# Surface Water Advisory Group Compiled Comments from SWAG Meeting #2

Updated: October 13, 2020

### **ECOS, The Nature Conservancy, Environmental Defense Fund, and Cosumnes Coalition Initial Comments and Responses to SWAG Meeting # 2, September 25, 2020**

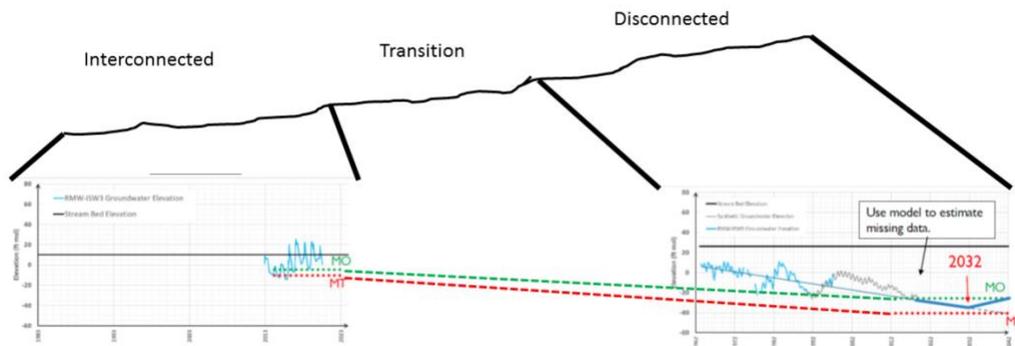
- Two approaches for SMCs were presented in the 9/16 Working Group meeting brief depending on if a river reach is determined to be interconnected or disconnected. If this strategy is identified as the preferred methodology please address the following comments:

- This strategy relies on discrete mapping of reaches as interconnected vs disconnected and that these boundaries remain stationary through time. It may be difficult to clearly identify boundaries of interconnection and it is likely such boundaries are subject to fluctuation through time (see next comment).

- Having two management strategies may create challenges at transitions from interconnection-to-disconnection (or visa-versa) as it creates a step change in MO/MT criteria. It may be necessary to create buffer regions between management units where interconnectedness is less clear to ensure management in disconnect reaches does not result in significant and undesirable impacts to interconnected reaches through propagation of declining groundwater levels that results in surface water depletions. In these buffer regions a separate management strategy may be needed with linear, sigmoidal, or other functional transitions between reaches (see concept figure below). In the absence of or even with this consideration in mind it must be shown that the SMCs for disconnected areas which allow continued lowering of GW tables will not impact nearby ISWs or the ability to achieve interconnected SMCs (Boulton & Hancock, 2006).

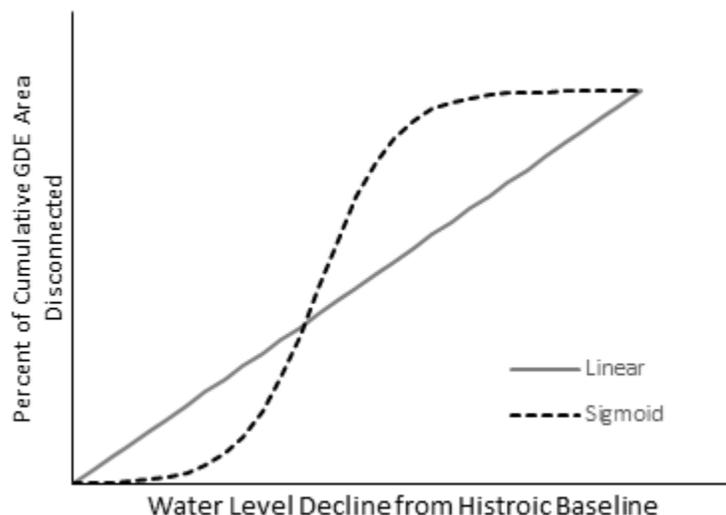
We suggest that part of the answer to this question is based on what we hope to accomplish with our partners in this basin. If these goals are not being achieved, then it is very likely that impacts are “significant and unreasonable.” Goals for the Cosumnes subbasin should include:

- Sustain water supply for agricultural, residential, and municipal use;
- Create fall flow conditions that allow salmon migration for spawning
- Sustain outgoing flow conditions for juvenile salmon migration
- Sustain/improve groundwater levels in riparian corridor to support existing GDEs from highway 16 to highway 99; and
- Sustain/improve groundwater levels for riparian forest and associated GDEs from highway 99 to highway 5 as necessary (groundwater levels are higher in this area).

In addition, when addressing undesirable result “6,” depletions of interconnected surface water [Water Code §10721(w)(6)], any additional depletions beyond January 2015 levels should be deemed “significant and unreasonable” and, therefore, an undesirable result. This is due to the history of overdraft in the subbasin, the massive public investment in the Cosumnes River Preserve (in excess of \$100 million), and the State Water Resources Control Board’s (State Water Board) designation of the Cosumnes River and other streams in the subbasin as “[fully appropriated streams](#)” (FAS). The Cosumnes is a FAS from July 1<sup>st</sup> to October 31<sup>st</sup>, the South Fork Cosumnes River is from April 15<sup>th</sup> to October 31<sup>st</sup>, and Deer Creek is from May 1<sup>st</sup> to October 31<sup>st</sup> ([see Order WR 98-08](#)). Due to these factors, the GSP should assume that any further depletions of interconnected surface water are impacting beneficial uses and are, therefore, “significant and unreasonable.” For a more detailed discussion of this topic see EDF’s white paper “[Addressing Regional Surface Water Depletions in California](#).”

It is possible that during normal, above normal, and wet water year types there will be “excess” water flowing in the Cosumnes River and other streams in the subbasin. In this case, some depletions of interconnected surface water may be reasonable, but much more detailed hydrologic analysis will be required to determine when there is truly excess water available before the GSP allows further depletions. The [State Water Board’s guidance for diversion of surface water to underground](#) storage may be a useful standard in the interim for determining if a depletion of interconnected surface water is reasonable. This guidance suggests that when stream flows exceed 90% of historical average daily flow between December 1<sup>st</sup> and March 31<sup>st</sup> it is safe to divert additional surface water for the purpose of groundwater recharge. We acknowledge this guidance is intended for a different purpose than assessing depletions of interconnected surface water, but believe it is a good rule of thumb until a more thorough analysis of the existing demands and beneficial uses along the streams of the subbasin is completed.

Lastly, several currently proposed SMCs cite 2015 water levels as the MO. As discussed in the section above it is possible this water level was already impacting beneficial uses (domestic wells/GDEs/ISWs) in the Basin. Please provide an analysis of the impact of this water level on these uses relative to a reasonable alternative baseline condition (e.g. average from 2005-2015 or longer period of record). This could be in the form of plots of incremental (i.e. 1 ft) water level declines from baseline vs resource metrics. Resource metrics could include: i) percentage of domestic wells that are dry; and ii) percent area of GDEs that become disconnected. The shape of such plots may be useful in understanding and classifying impacts (e.g. a linear response is much different than a sigmoidal response where a clear threshold of increased impact is present – see conceptual figure below).
